Access Compliance Report

Public Rights-of-Way

(Curb Ramps)

Intersection ID: 48560	Main Street: WOODLAND_WATCH_CT	Cross Street: ARDREY_WOODS_DR	Location: E
ADA ID: 105A7A2D9683	Ramp Type: PerpDiag	Initial Pass/Fail: Fail	Overall Compliance: No
Severity Score: 25			
Codes/Mitigation Info/Possible Solution		Field Measurements/Component Compliance

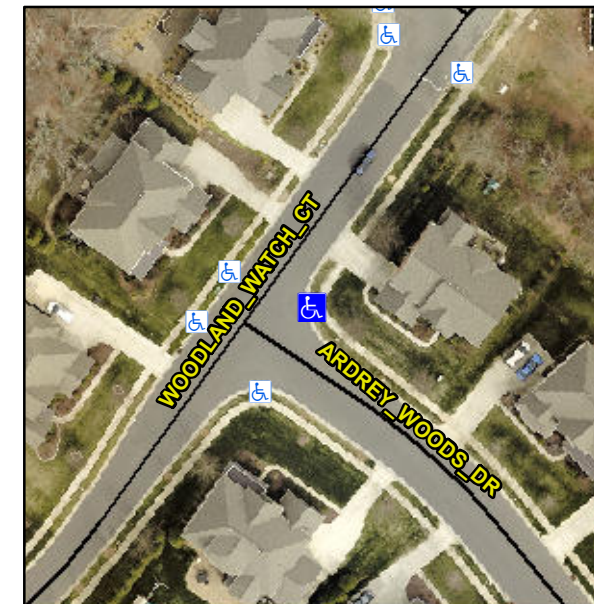
Not Found, R304.5.3

Compliance	Description	Data	Compliance	Description	Data
N/A	Ramp Length (in)	51.0	Yes	Ramp Slope (%)	6.8
Yes	Ramp Width (in)	48.0	No	Ramp XSlope (%)	12.2
N/A	Flare Type LT	N/A	N/A	Flare Type RT	N/A
N/A	Flare Slope LT (%)	N/A	N/A	Flare Slope RT (%)	N/A
N/A	Flare Traversable LT?	N/A	N/A	Flare Traversable RT?	N/A
N/A	Landing Length (in)	N/A	N/A	DWS Provided?	N/A
N/A	Landing Width (in)	N/A	N/A	DWS Contrast?	N/A
N/A	Landing Slope (%)	N/A	N/A	DWS Length (in)	N/A
N/A	Landing X Slope (%)	N/A	N/A	DWS Full Width?	N/A
N/A	Landing Curb? (Y/N)	N/A	N/A	DWS Offset (in)	N/A
N/A	Shared Landing?	N/A			
N/A	Gutter Ponding?	N/A	N/A	Gutter Slope (%)	N/A
N/A	Gutter Lip Ht (in)	N/A	N/A	Gutter X Slope (%)	N/A
N/A	Painted X Walk1?	No	N/A	Painted X Walk2?	No
	X Walk 1 Direction	To NW		X Walk 2 Direction	To SW
N/A	X Walk 1 Width (in)	N/A	N/A	X Walk 2 Width (in)	N/A
	X Walk 1 Slope (%)	7.0		X Walk 2 Slope (%)	2.0
	X Walk 1 X Slope (%)	5.5		X Walk 2 X Slope (%)	9.5

Remove & Replace Curb Ramp With Two New Directional Ramps or Equivalent.
